## Product Service Bulletin

**SUBJECT:** TORQUE CONVERTER CLUTCH (TCC) CHUGGLE/HUNTING CONDITION

**MODELS:** 1989-1995 GEO TRACKER, CAMI VITARA, SUZUKI SIDEKICK  
WITH HYDRA-MATIC 3L30 AUTOMATIC TRANSMISSION

**SUBJECT:** MODIFICATION OF ENGINE CONTROL MODULE (ECM)  
**MODEL:** SIDEKICK 2-DOOR WITH GM 3-SPEED AUTOMATIC TRANSMISSION  
**YEAR:** 1995 AND LATER

Figure 1

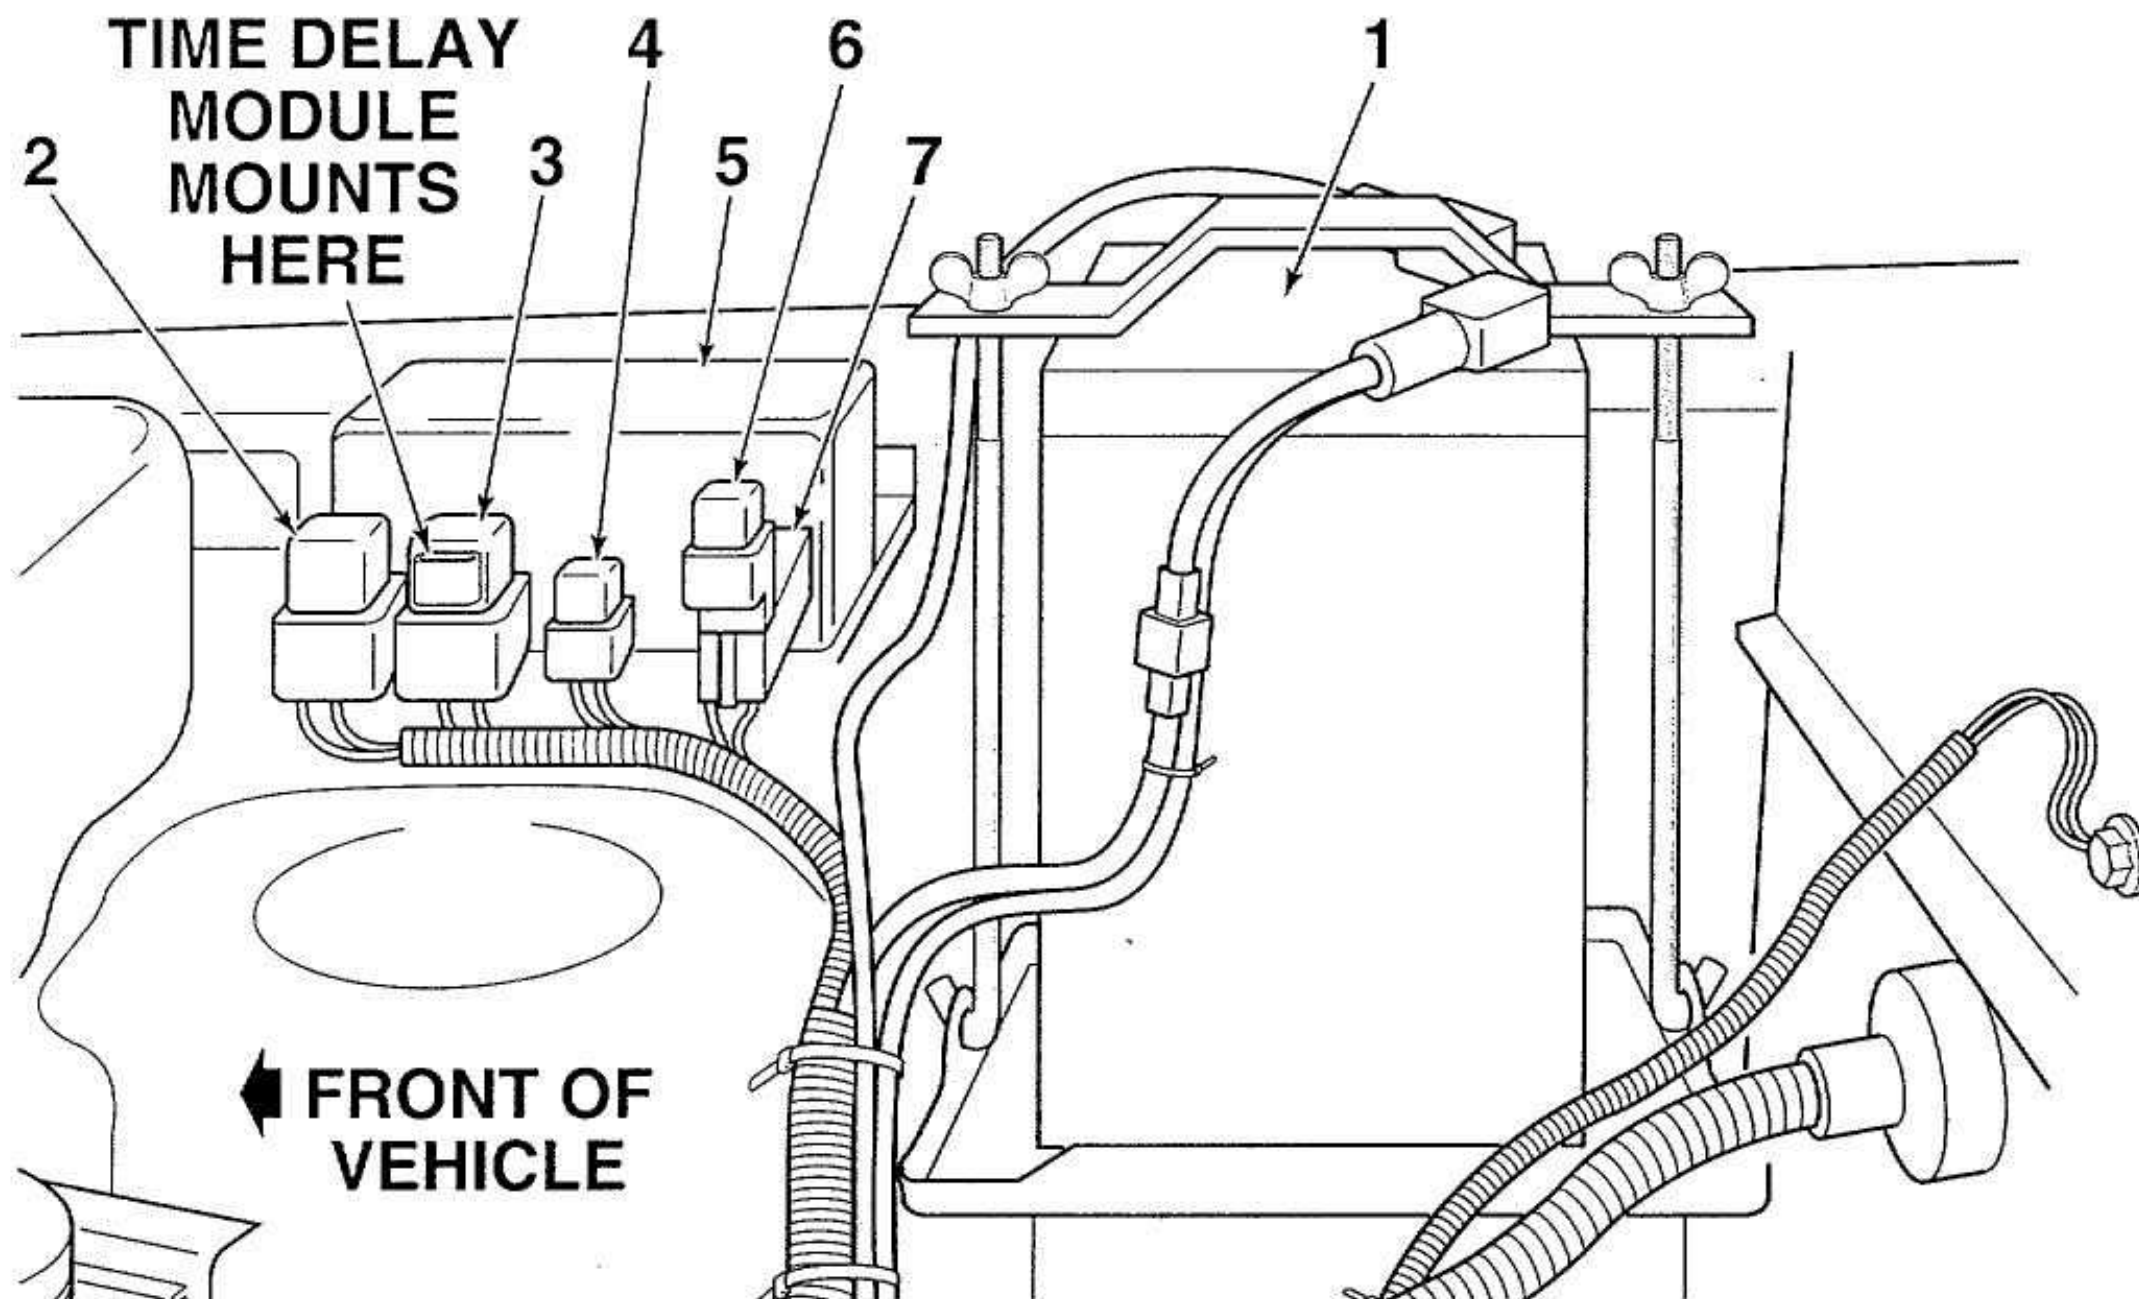
3. Disconnect the white wire from the green connector. Remove the terminal **carefully** with a narrow screwdriver as indicated. (Figure 1)
4. Connect the white wire to the Time Delay Module and wrap with electrical tape. Install the red wire from the Time Delay Module into the open terminal of the green TCC relay connector. (Figure 4)
5. Reconnect the green connector to the TCC relay and install the TCC relay onto the relay center. (Figure 4)
6. Clip the Time Delay Module onto the A/C fan relay. (Figure 3)

**Figure 1**

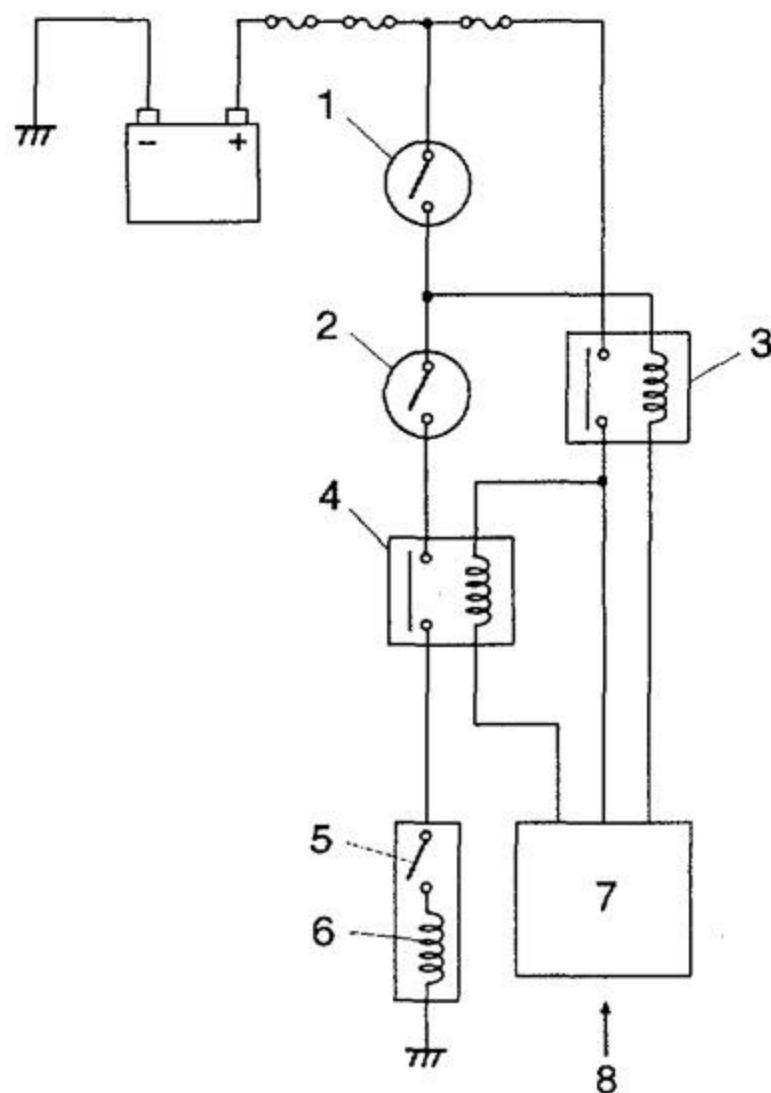
This bulletin is to inform you of a modification in the ECM which is effective in 1995 model year vehicles matching or exceeding the VIN numbers listed below. The Torque Converter Clutch (TCC) Relay Control System in 1995 and later 2-door Sidekick Automatic Transmissions has been modified to operate through ECM control, replacing the Pressure Switch in the valve body. Because of this modification, the ECM and the diagnostic procedures related to the TCC Relay Control System have been changed. If the vehicle matches or exceeds the starting VIN numbers listed below, please use the diagnostic procedures as listed in this bulletin.

This system controls the TCC relay, one of the components that controls the torque converter clutch. A circuit diagram of this system is shown in Figure 1.

- Engine is running
- Engine coolant temperature is above 60°C (140°F)
- Throttle valve opening is between 6.4° and 62.5
- Vehicle speed is higher than
  - 40 mph (64 km/h, 8-valve engine) or
  - 47 mph (75 km/h, 16-valve engine, late type ECM only).

## TORQUE CONVERTER CLUTCH DIAGNOSIS (LATE TYPE ECM)

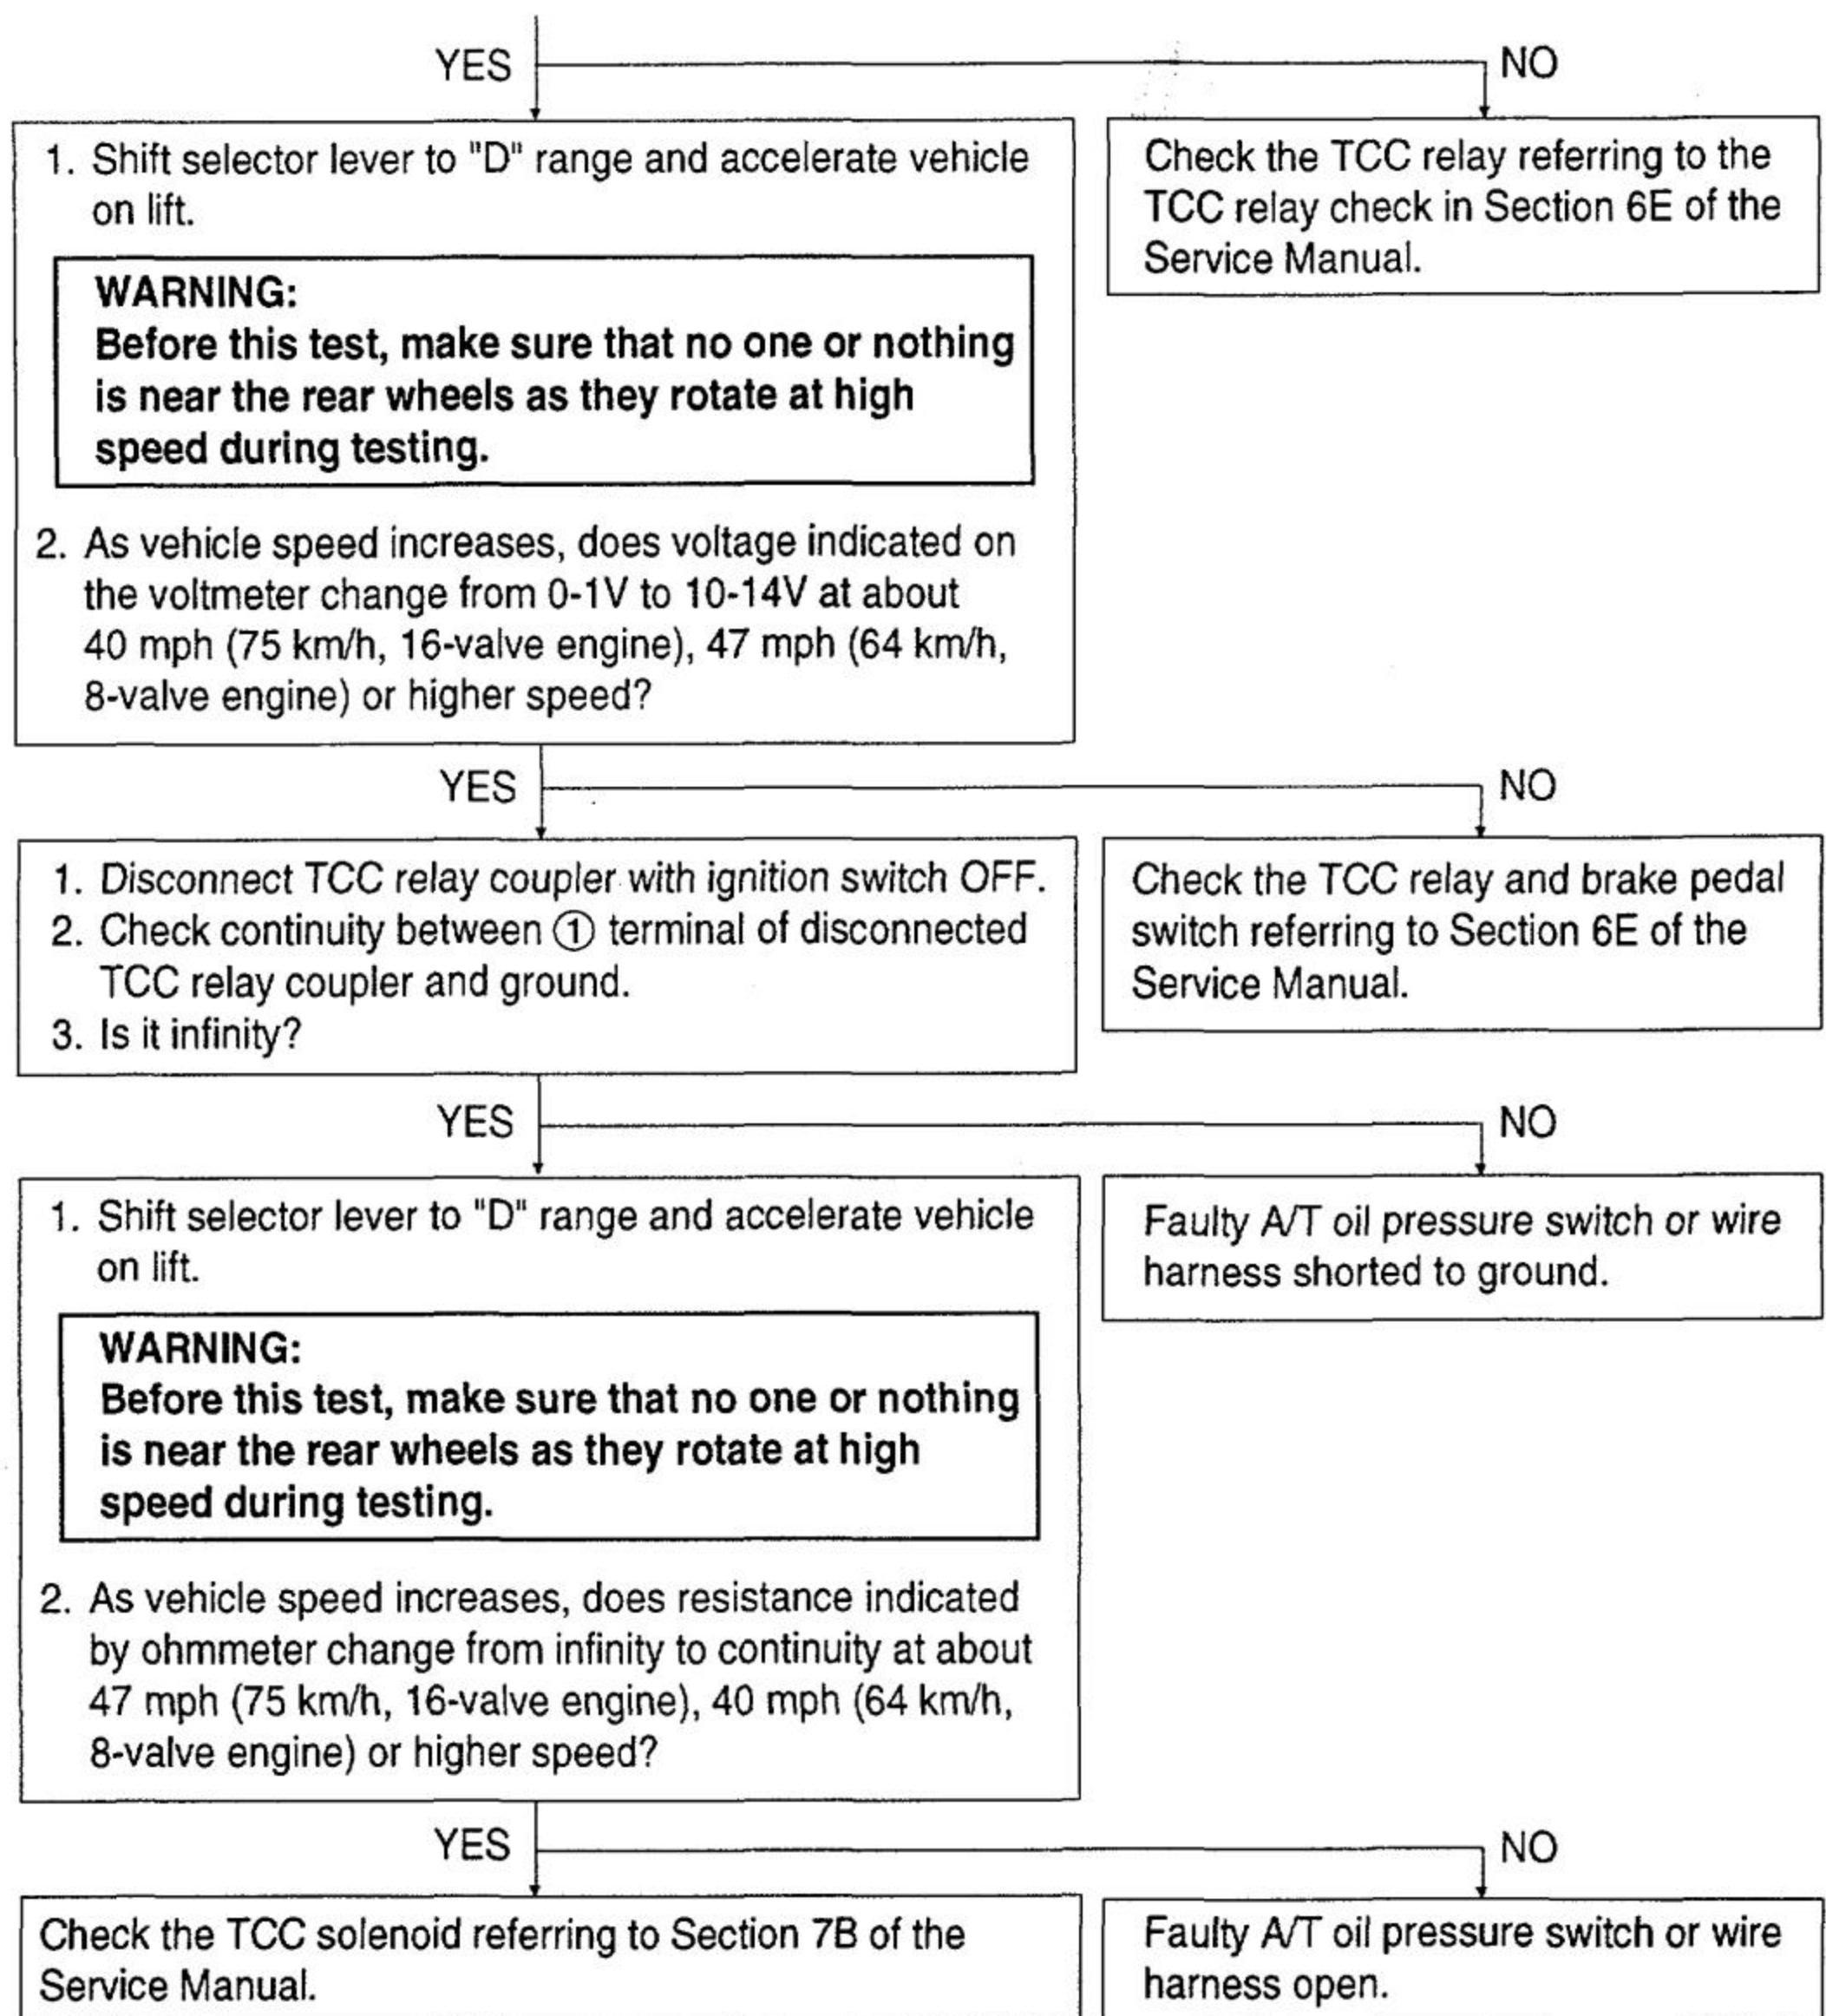
1. Connect a voltmeter between A11 terminal of the ECM coupler and body ground with ignition switch OFF.
2. Check voltage with ignition switch ON. Is it 10-14 V?

3. Shift select lever to "D" range and accelerate vehicle on lift.
4. As the vehicle speed increases, does voltage indicated by the voltmeter change from 10-14 V to 0-1 V at about 47 mph (75 km/h, 16-valve engine), 40 mph (64 km/h, 8-valve engine) or higher speed?

1. Connect a voltmeter between terminal ① of the TCC relay and ground.
2. Check voltage with ignition switch ON. Is it 0-1 V?

Poor A11 connection. If connection is OK, substitute a known-good ECM and recheck.

**EARLY**

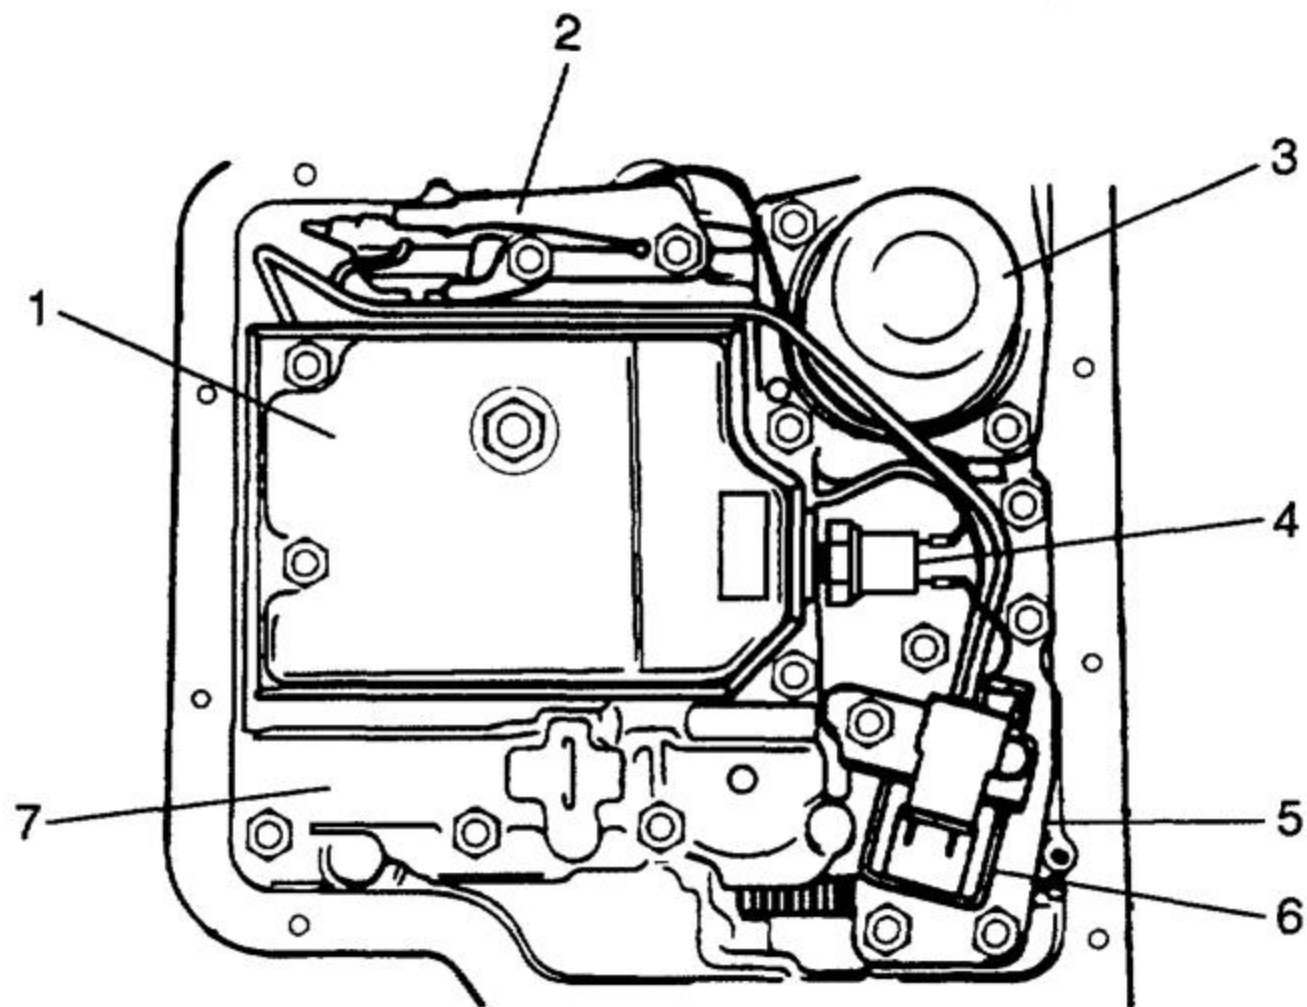
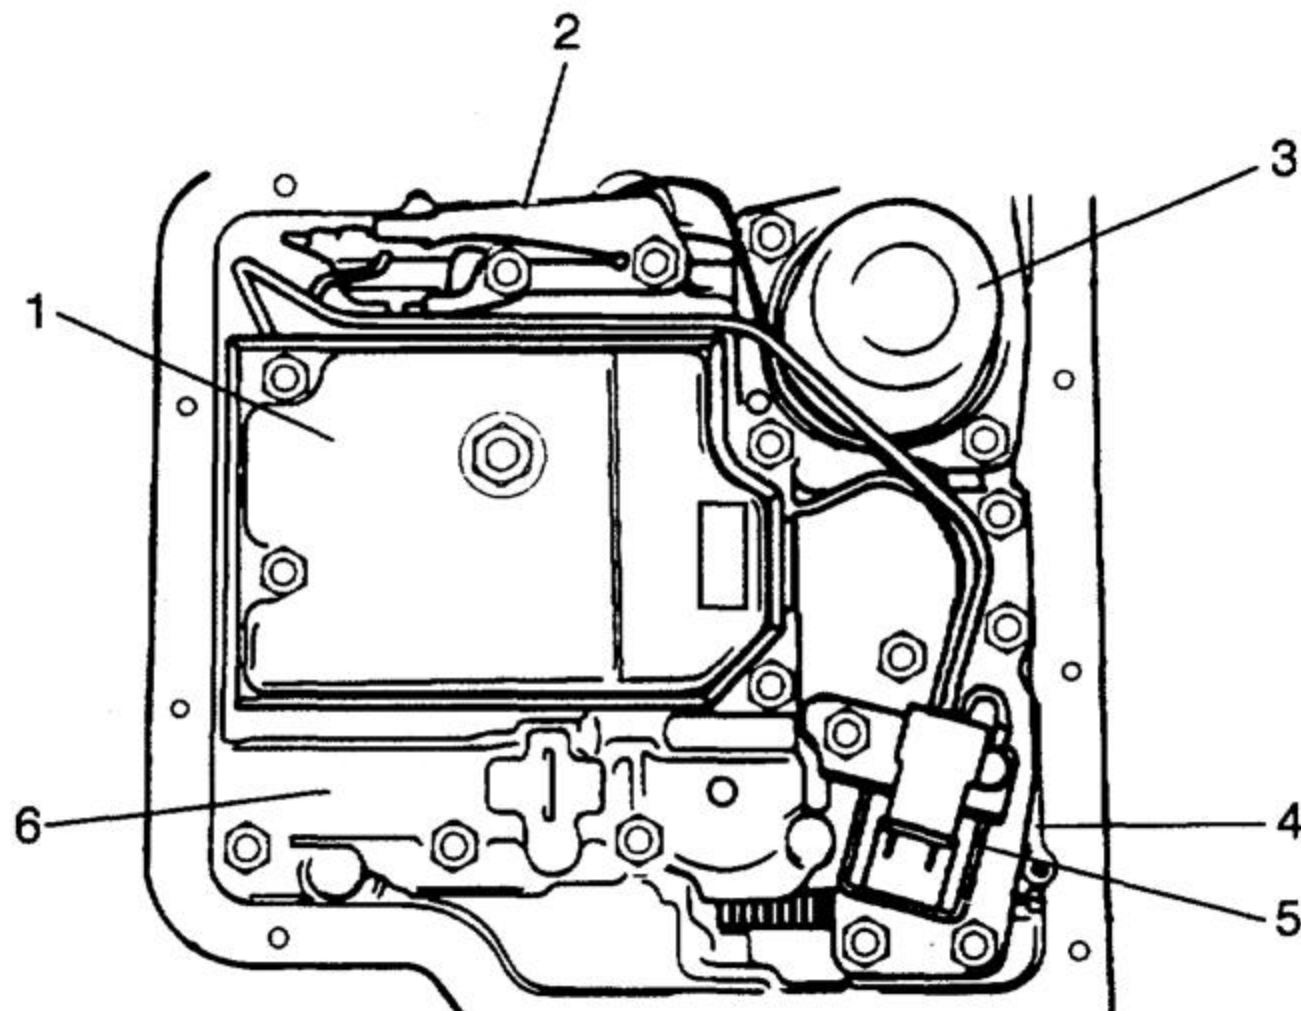
**CONDITION:** Change in Automatic Transmission; elimination of A/T oil pressure switch.

This bulletin is to inform you of the elimination of the Torque Converter Clutch (TCC) Oil Pressure Switch which has been carried out since May 1995 production for Canadian models and August 1995 production for Japan models. Due to this modification, the diagnostic procedures for the TCC system in the service manual have been changed. Please refer to Technical Service Bulletin #TS 3-25 to diagnose this system.
